REPORT TO COMMITTEE

RE: APPLICATION BY CHARAN SETHI FOR REZONING AT 11611, 11631 AND 11651 WILLIAMS ROAD FROM SINGLE-FAMILY HOUSING DISTRICT, SUBDIVISION AREA E (R1/E) TO SINGLE-FAMILY HOUSING DISTRICT, SUBDIVISION AREA K (R1/K)

RE: Response to Mr. Dale Pitts Re RZ 01-114608

POLICY 5409
SECTION 25, 4-6

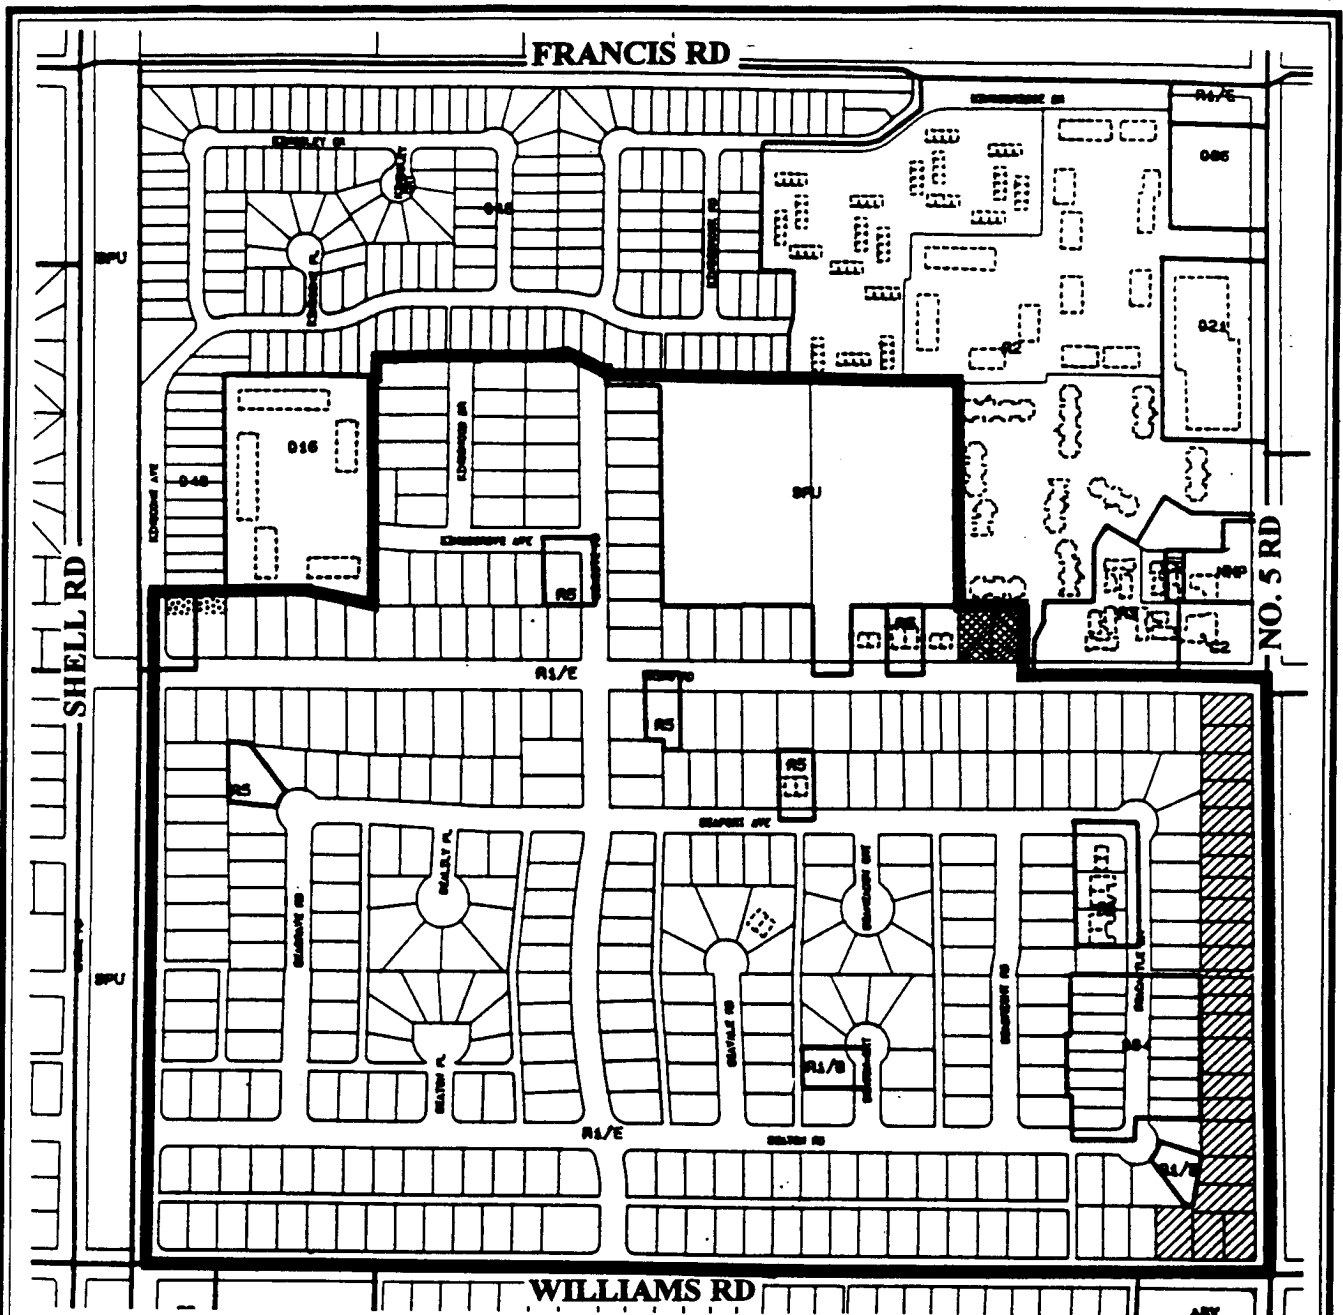
- b) Attachment 3: The lower left hand corner of the properties indicated should be indicated as R1/C.
 - c) Both Attachment 1 and 3 in my opinion should be reissued in full, or in part, as an addendum to all affected residents.

- 1a) Attachment 1 incorrectly labels the elevation shown as the "North Elevation". The drawing should read "South Elevation";
- 1b) The lower left hand corner properties along Williams Road, under the proposed amendment to the Policy, will no longer have an R1/C designation as part of the Lot Size Policy;
- 1c) Staff do not believe that the mislabelling of the south elevation warrants reissuing letters to the neighbourhood;
